Access Compliance Report

Public Rights-of-Way

Intersection ID: 18844	Main Street: NATIONS_FORD_RD	Cross Street: TYVOLA_RD	Location: SE
ADA ID: 79165778E5C4	Ramp Type: PerpDiag	Initial Pass/Fail: Fail	Overall Compliance: No
Severity Score: 13.75			
Codes/Mitigation Info/Possible Solution		Field Measurements/Component Compliance

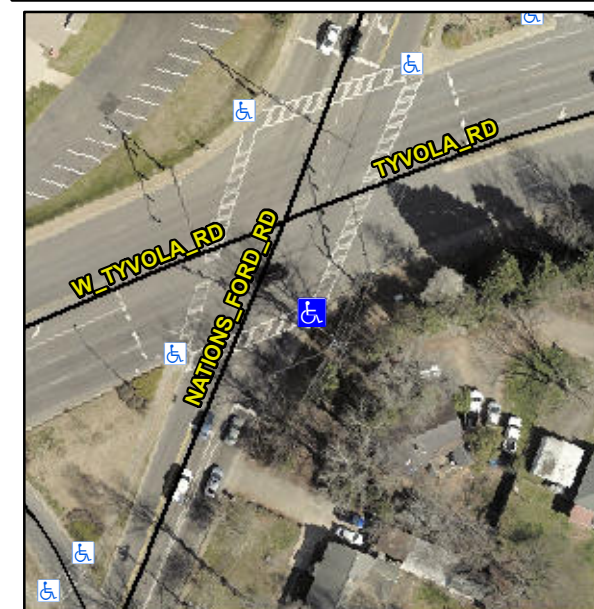
Remove & Replace Curb Ramp With Two New Directional Ramps or Equivalent.

R304.2.2, R304.5.3
